**ROCKFORD BOARD OF EDUCATION
INVITATION FOR BID ON SUPPLIES, MATERIALS, EQUIPMENT OR SERVICES
FOR SCHOOL DISTRICT NO. 205
ROCKFORD, ILLINOIS**

RFQ No. **16-22 Riverdahl Elementary School Additions**

RE: **ADDENDUM NO. 2**

KEYED NEW DUCTWORK NOTES # :

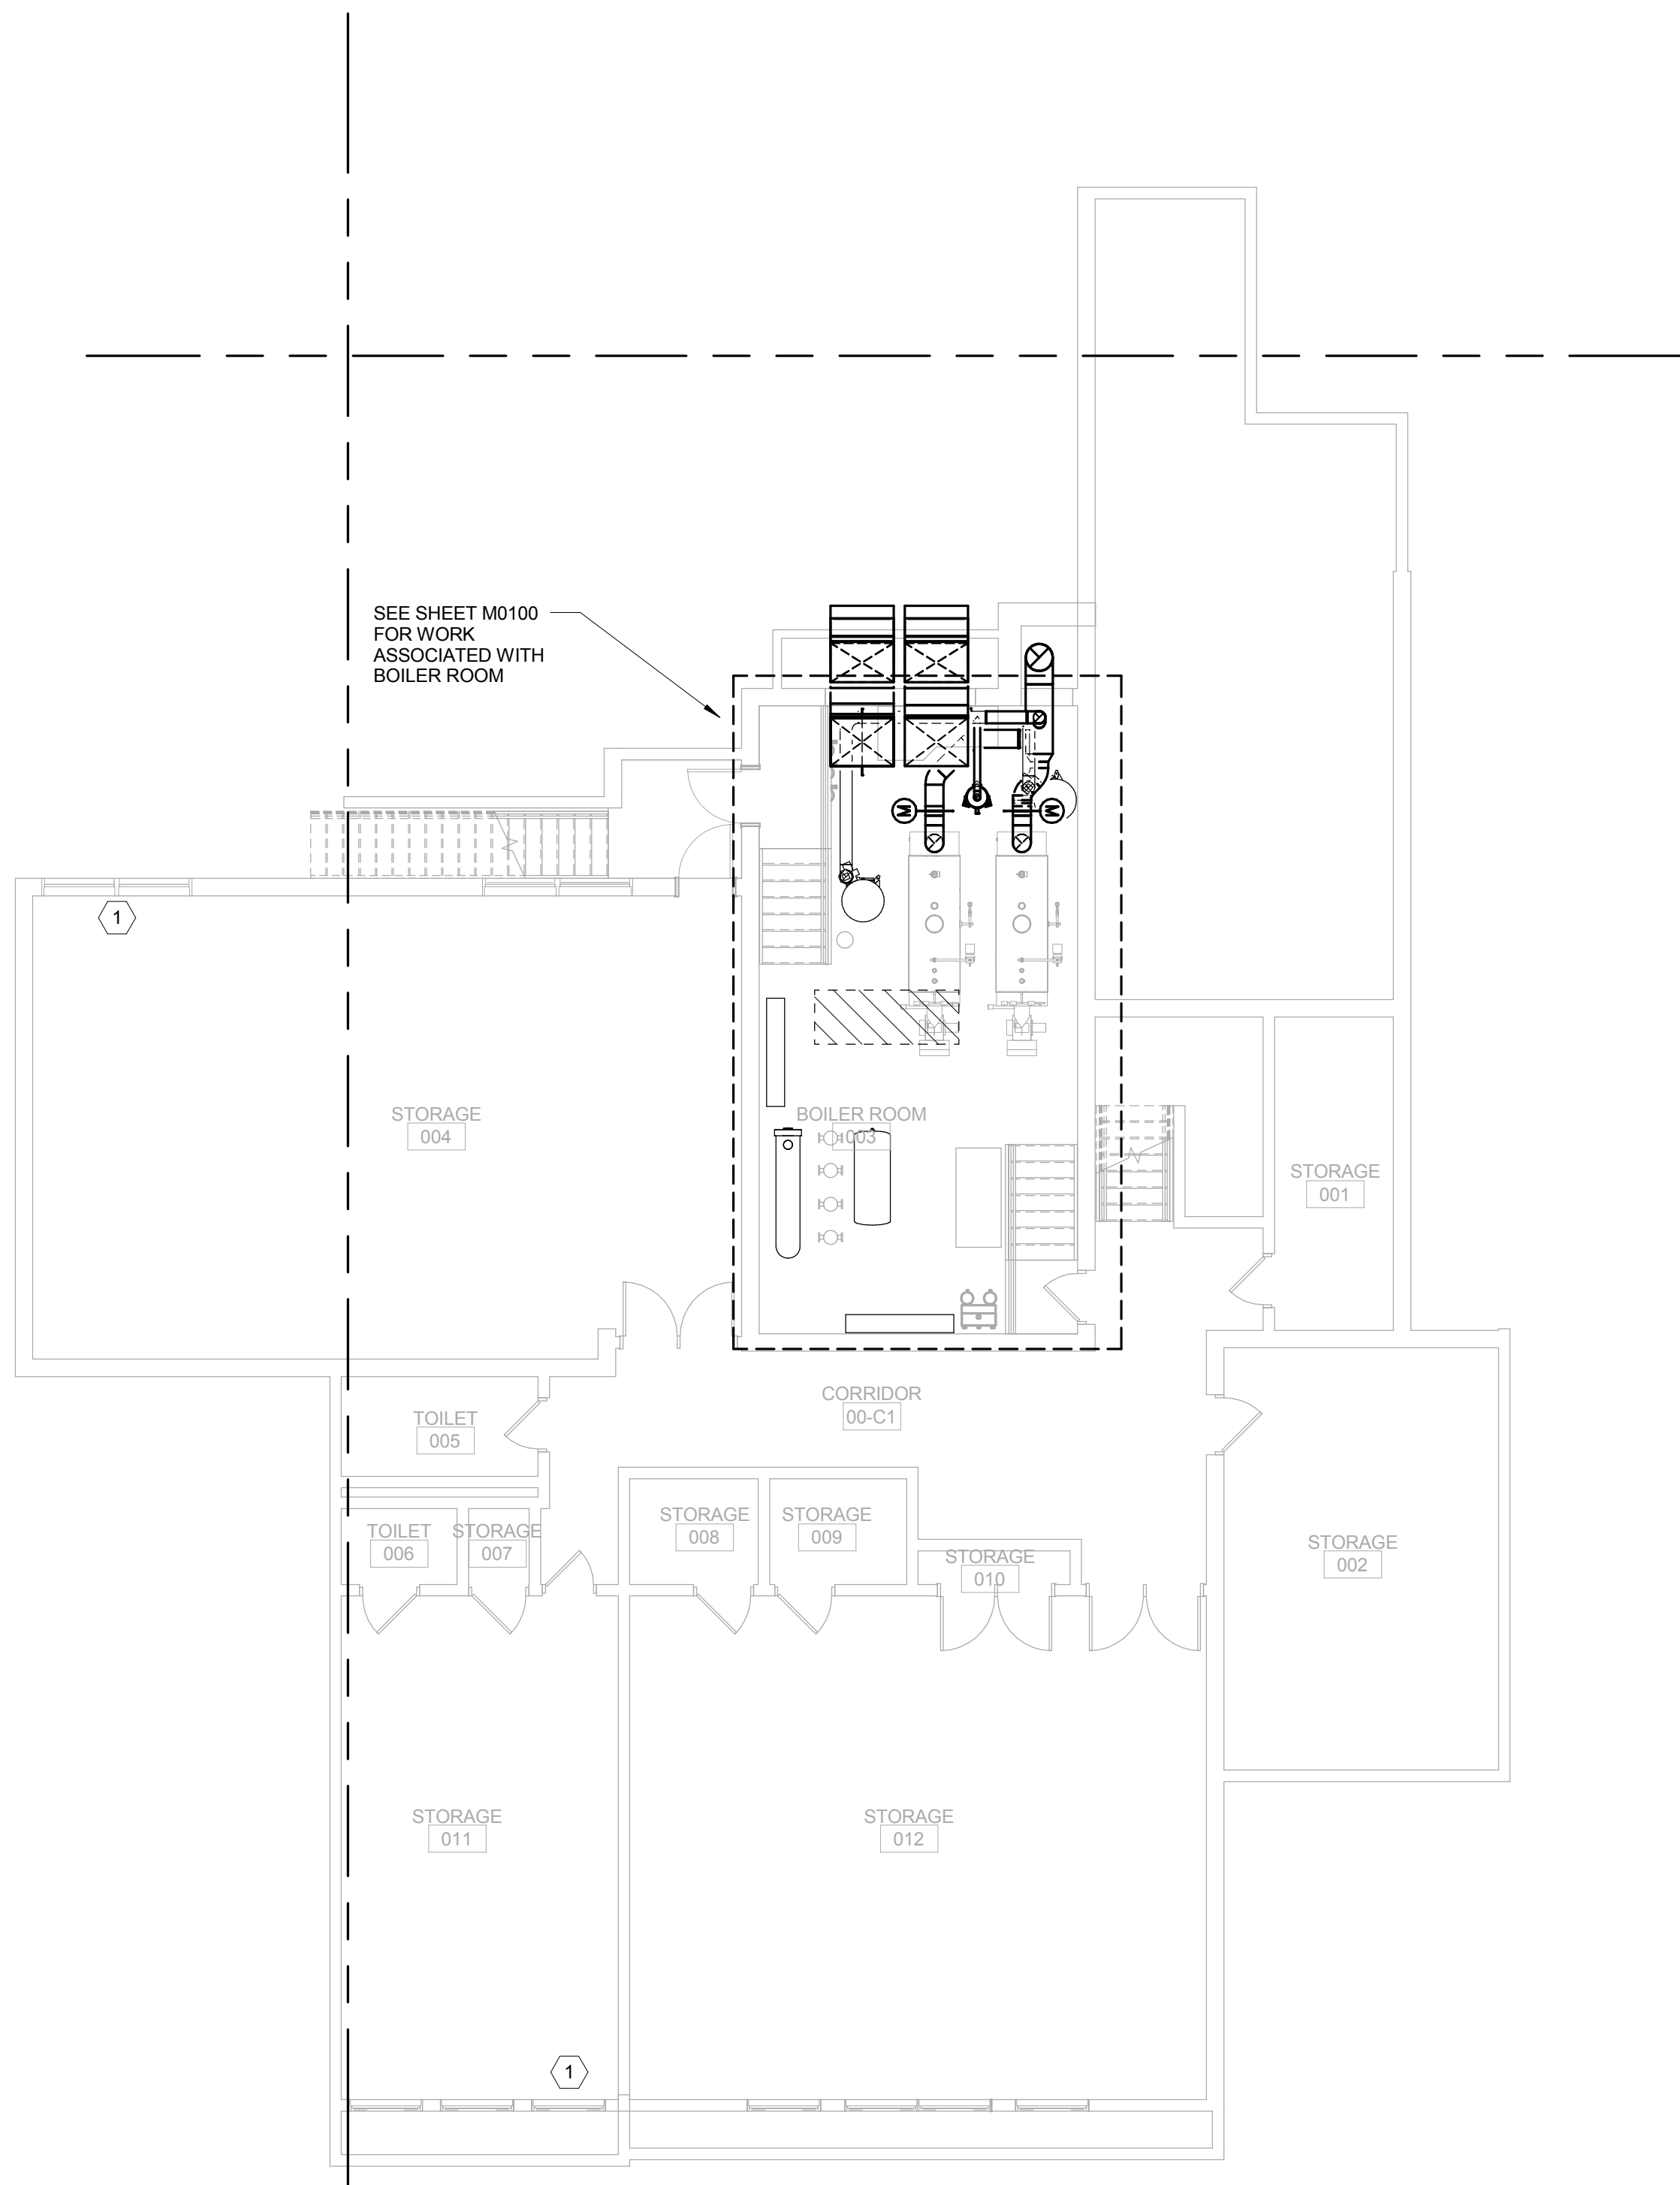
- A. Drawing M0100.E is being issued as an attachment to this Addendum. This is a new sheet to show scope of work if Alternate 2B is taken.
23. E0101.B – LEVEL 01 LIGHTING PLAN – AREA B

LEVEL 01 LIGHTING PLAN
- AREA E

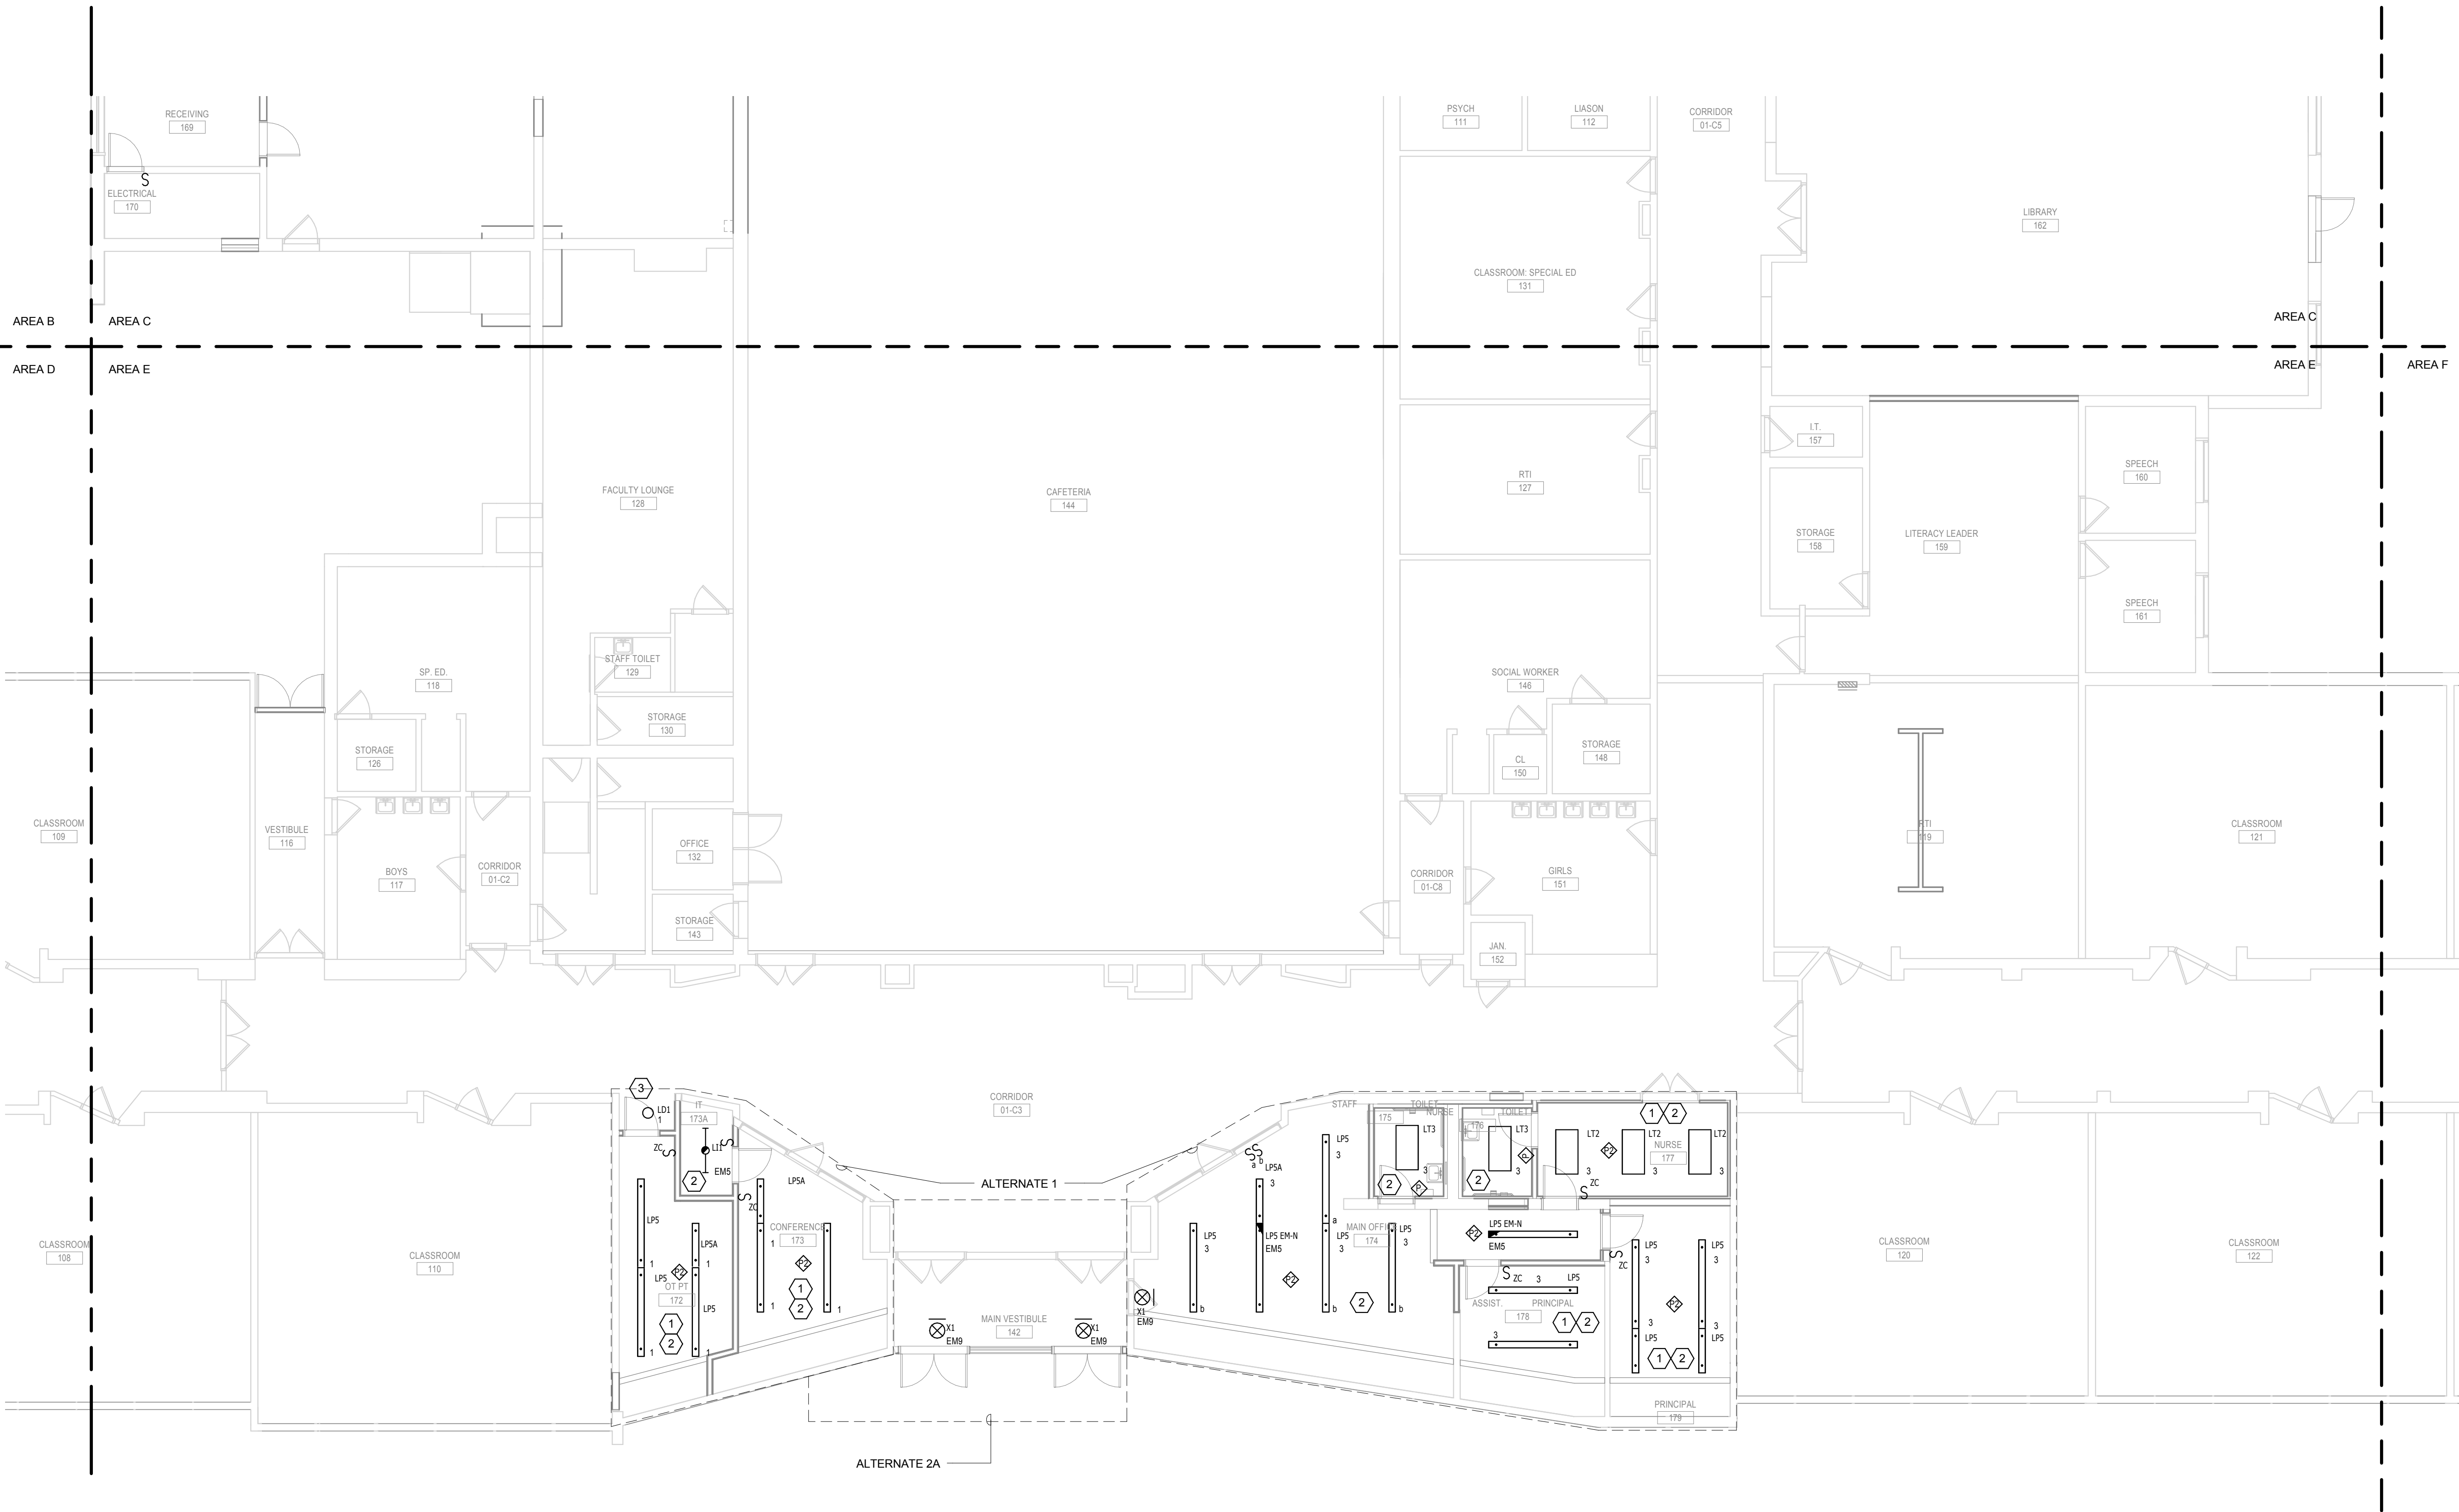
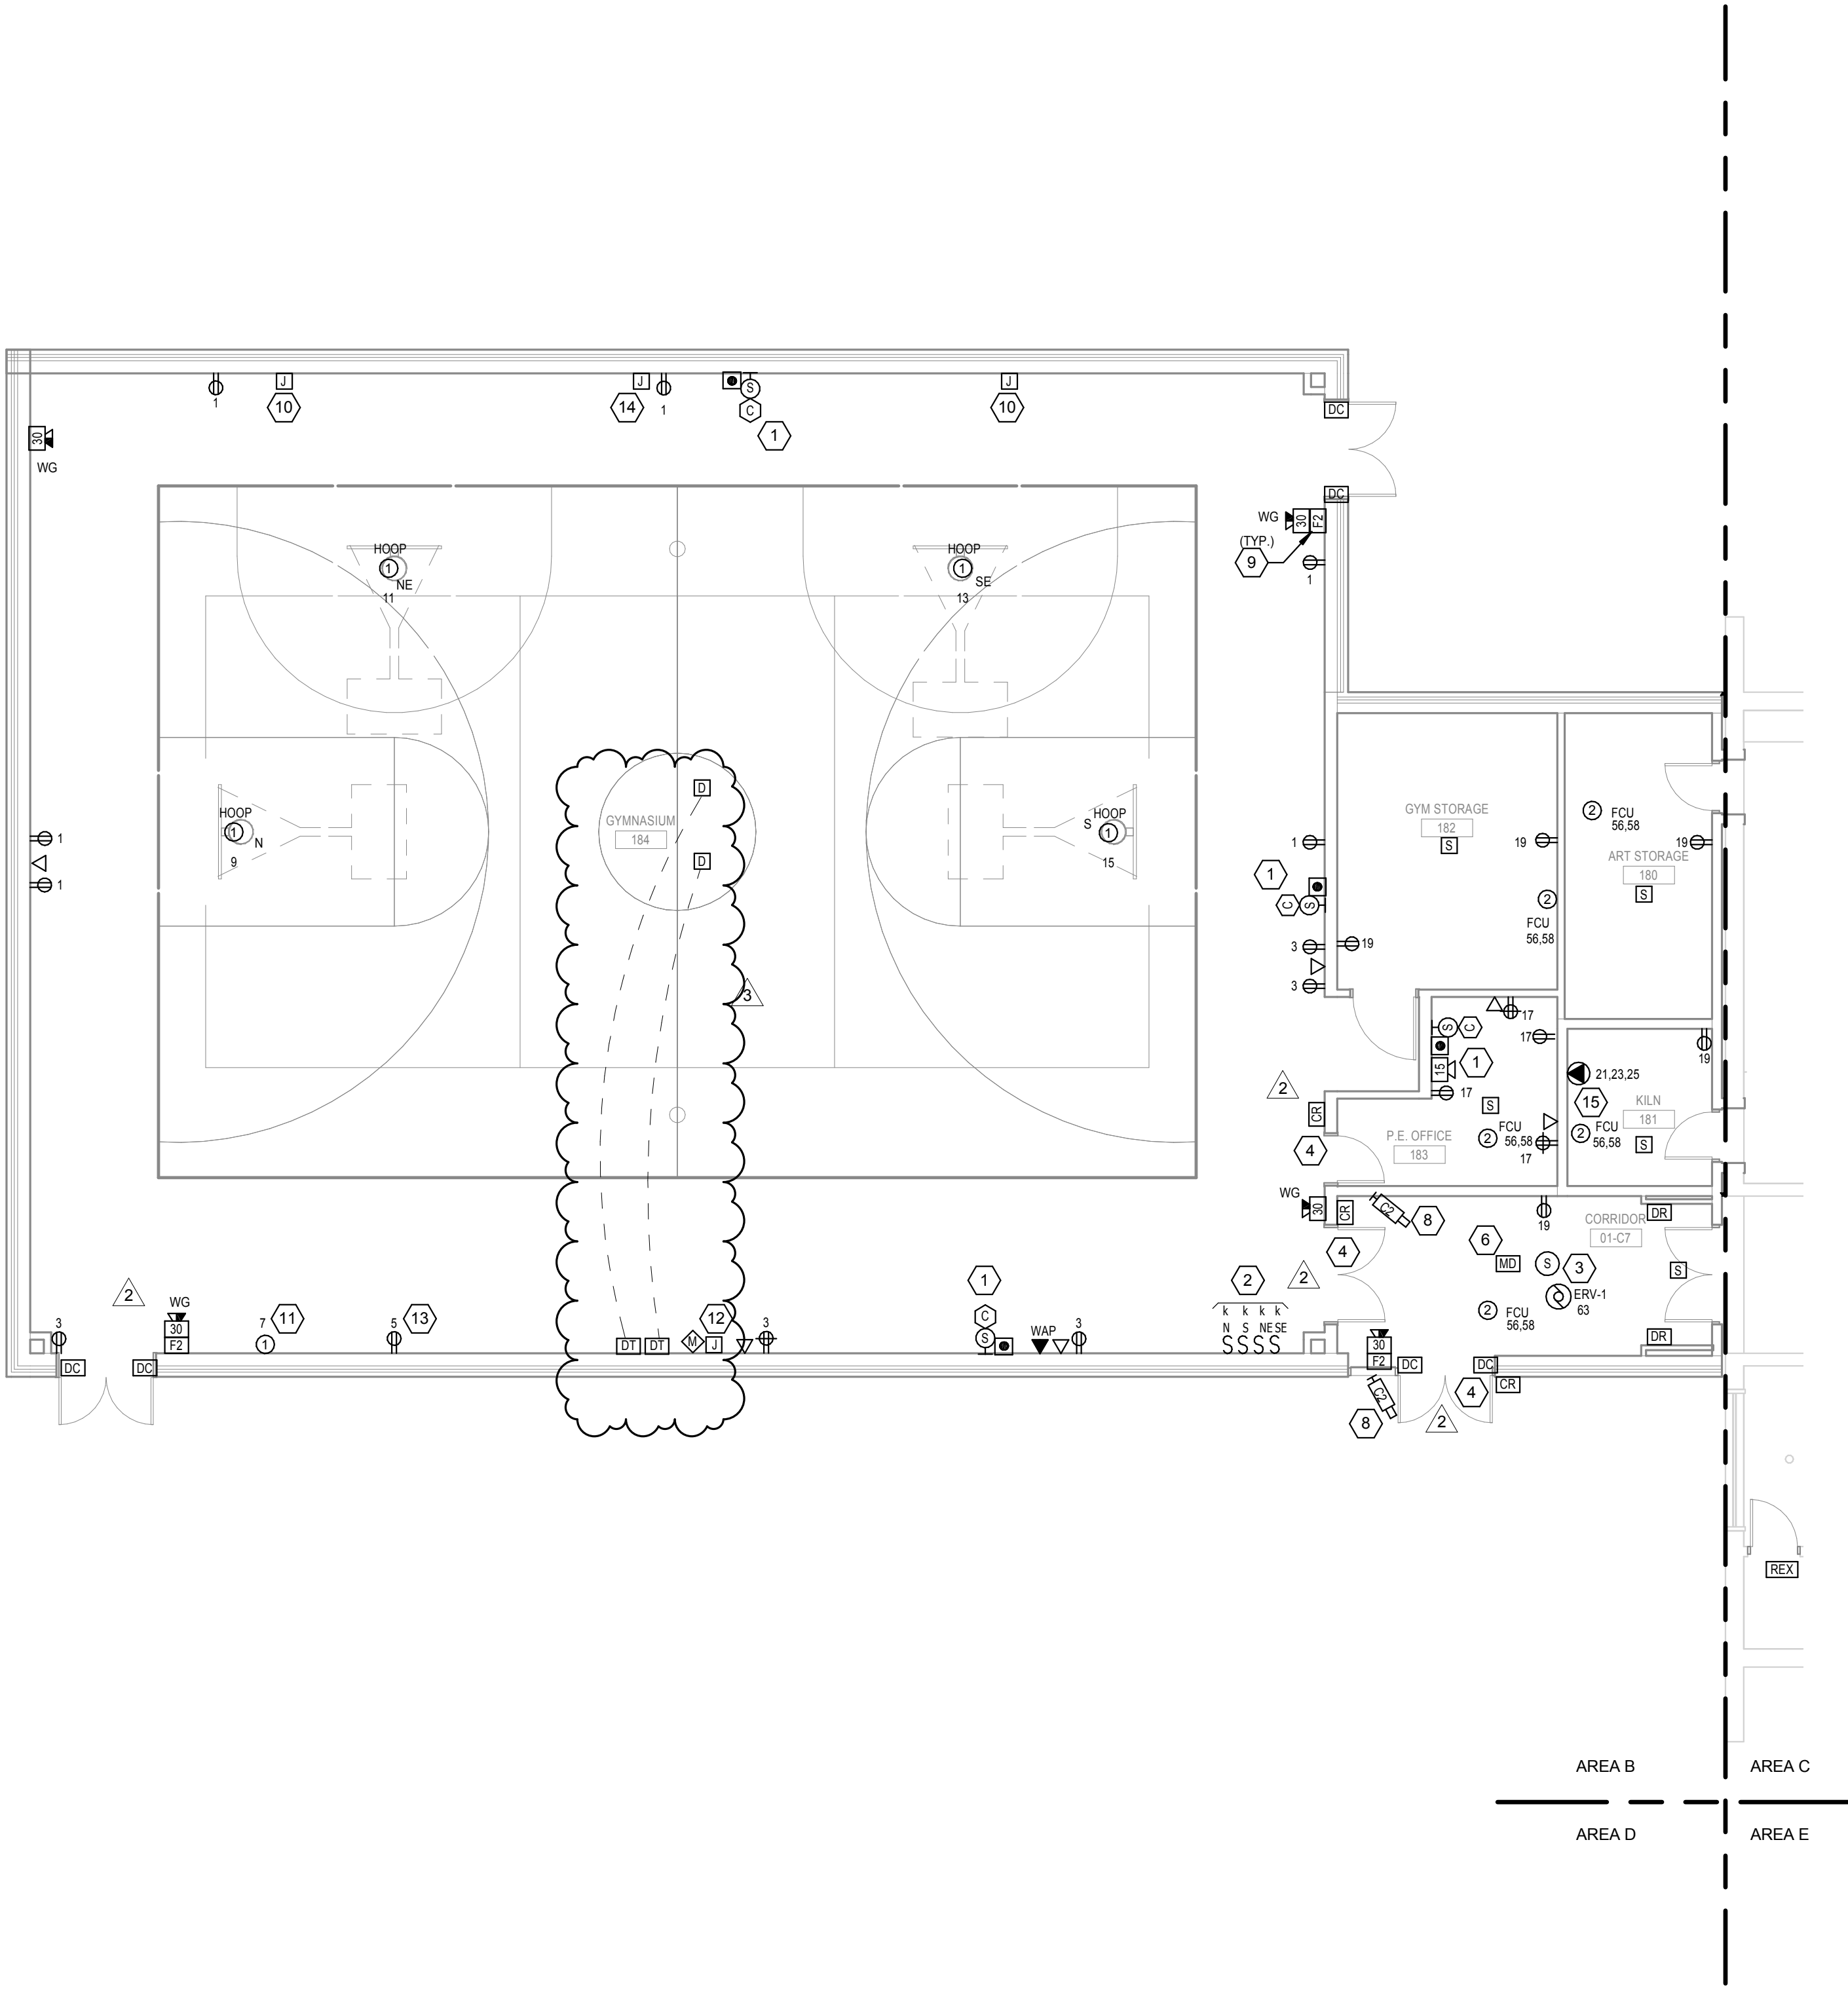
- B. Keyed note 5 has been deleted.
- 25. E0101.E – LEVEL 01 LIGHTING PLAN – AREA E
 - A. Life safety branch circuit note updated.
- 26. E0200 – BASEMENT POWER AND SYSTEMS PLAN
 - A. Emergency generator tagged as existing.
 - B. Keyed note 6 has been corrected.
- 27. E0201.B – LEVEL 01 POWER AND SYSTEMS PLAN – AREA B
 - A. Duct detector connections updated.
 - B. Keyed note 15 has been updated.
- 28. E0201.C – LEVEL 01 POWER AND SYSTEMS PLAN – AREA C
 - A. Smoke detector added to STAFF TOILET 168.
- 29. E0201.E – LEVEL 01 POWER AND SYSTEMS PLAN – AREA E
 - A. Request to Exit devices added at doors to IT 173A, MAIN VESTIBULE 142, and MAIN OFFICE 174.
- 30. E0421 – ENLARGED PLANS
 - A. Keyed note 4 updated.
- 31. E0521 – POWER RISER DIAGRAMS
 - A. RTU-3 circuit breaker size changed to 40AT/100AF.
